Product Change Notification

TRIMPOT® TRIMMING POTENTIOMETERS

Bourns® Trimpot® Product Line Announces Product Change for Model 3313

Current Model

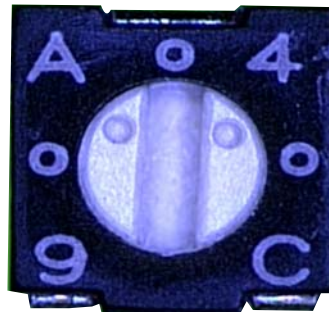
Bourns® Trimpot® Product Line has updated the housing material for the Bourns® Model 3313. This improved housing material is now halogen free**. There is no change to form (except color), fit or function. The halogen free material will come in a black color. A benefit of this color change is an enhanced contrast in marking.

We will begin phasing in this material on April 1, 2012.

- The effective date code will read 2E.
- The expected last date of manufacture of the current product is April 15, 2012.
